NSLPP MEETING HELD ON 03/03/21

ADDRESS/WARD: 229 and 231 Miller Street, North Sydney

APPLICATION NO: DA 5/21

PROPOSAL: Installation of three (3) business identification signs.

Figure 1 – Proposed Sign 1

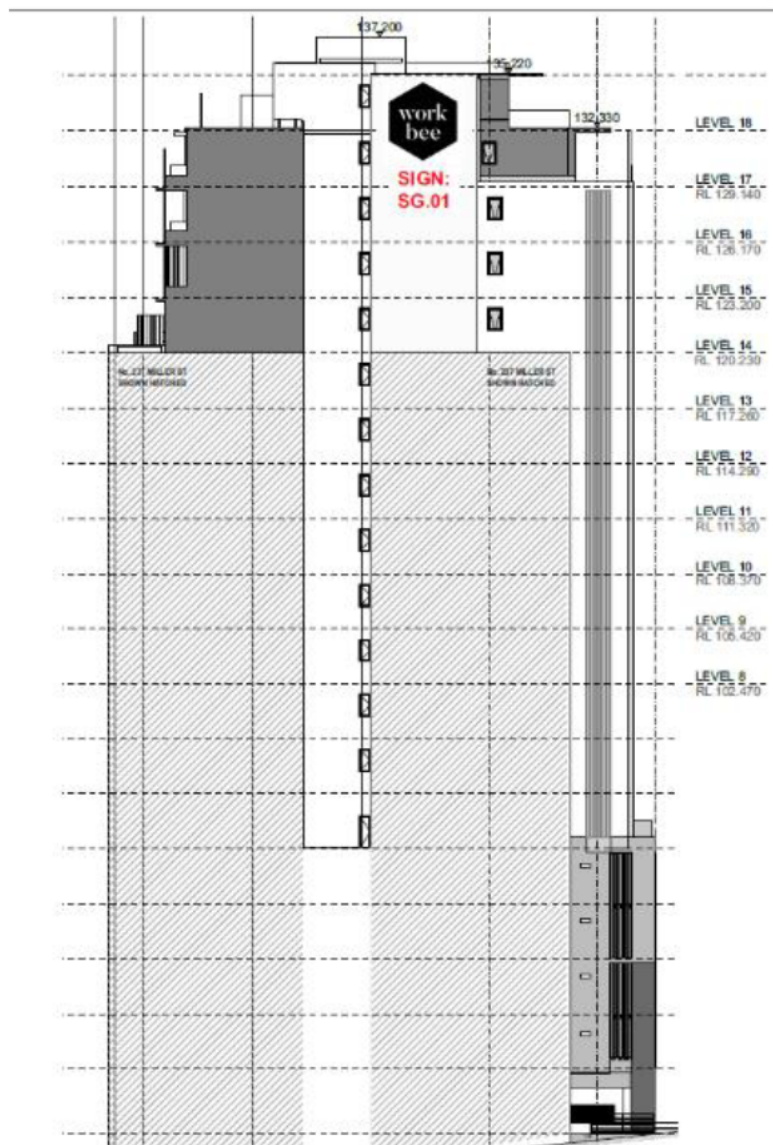
The proposed Sign 1 is not supported as the applicant's Clause 4.6 variation statement is considered not to be well-founded, and has not provided sufficient environmental planning grounds to justify a breach of the development standard. In addition, the proposed Sign 1 has been considered to not to be in the public interest, as it is inconsistent with the objectives of the building height development standard and the objectives for the B4 Mixed Use Zone. Even if the Clause 4.6 variation statement was acceptable the proposal, on a whole would remain unacceptable.

The proposed **Sign 1** is not considered to be defined as a ‘*business identification sign*’. The proposed Sign 1 is therefore defined as a ‘*advertisement structure*’ or more accurately defined as a ‘*roof or sky advertisement*’ as per the definitions outlined in the SEPP 64.

Sign 1 is located on the northern elevation of No. 231 Miller Street and is highly visible from the public domain given its size. Currently, there are no recently approved roof or sky advertisement signs located in the B4 Mixed Use Zone. Sign 1 is considered to be out of context given the proposal is located within a predominately residential setting that is 229 Miller Street and 231 Miller Street. A condition of consent has been recommended to delete Sign 1 from the proposal.

Delete Sign 1

Figure 2 – Proposed Signage Dimensions

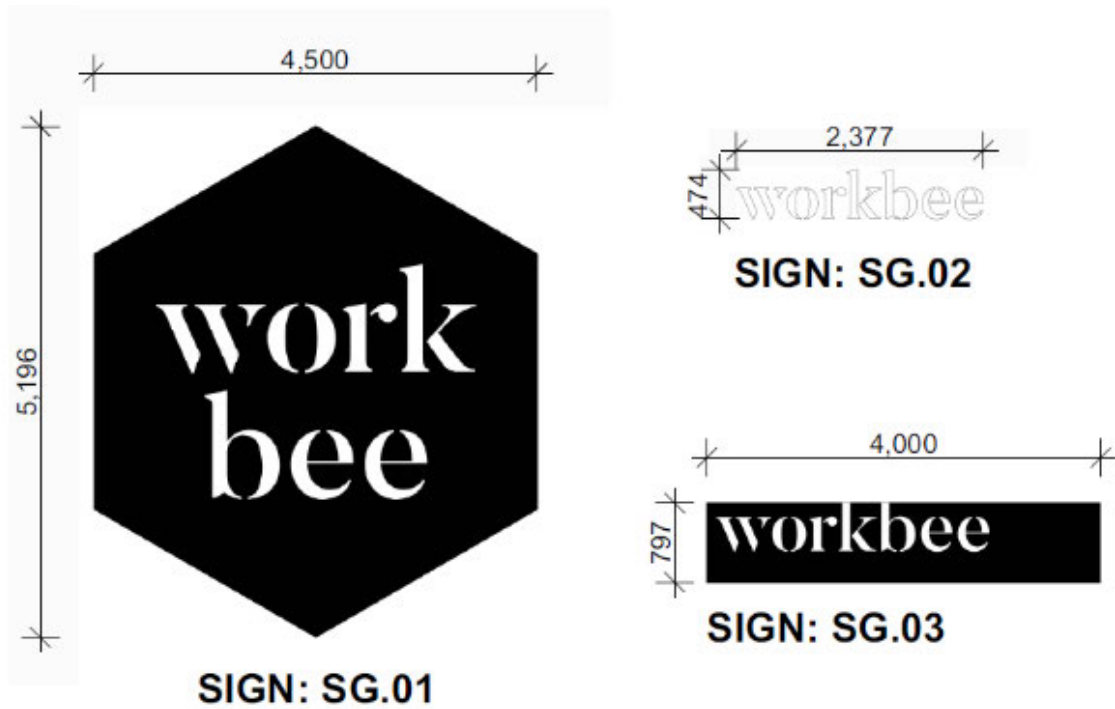
The design of the proposed ground floor signage (Sign 2 and Sign 3) is supported as it would identify the commercial tenancy on the ground floor at No. 229 Miller Street as well as being similar to the existing signage in size, colour and dimensions. The design, form and illumination impacts of the proposed signage can be reasonably modified by conditions to address amenity impacts and is consistent with what is reasonable expected in a mixed use zone.

The proposed **Sign 2** is also not considered to be defined as a ‘*business identification sign*’ due to its location being on the awning structure of the building at No. 231 Miller Street, North Sydney. For that reason, the proposed Sign 2 is therefore defined as a ‘*advertisement structure*’ per the definitions outlined in SEPP 64.

Response: The illumination of Sign 2 is considered to be acceptable subject to conditions. A condition has been included ensuring that Sign 2 is not illuminated between 9.00pm -7.00am daily.

- I1. All illuminated signs approved by this consent must cease illumination between the hours of 9.00 pm and 7.00 am daily.
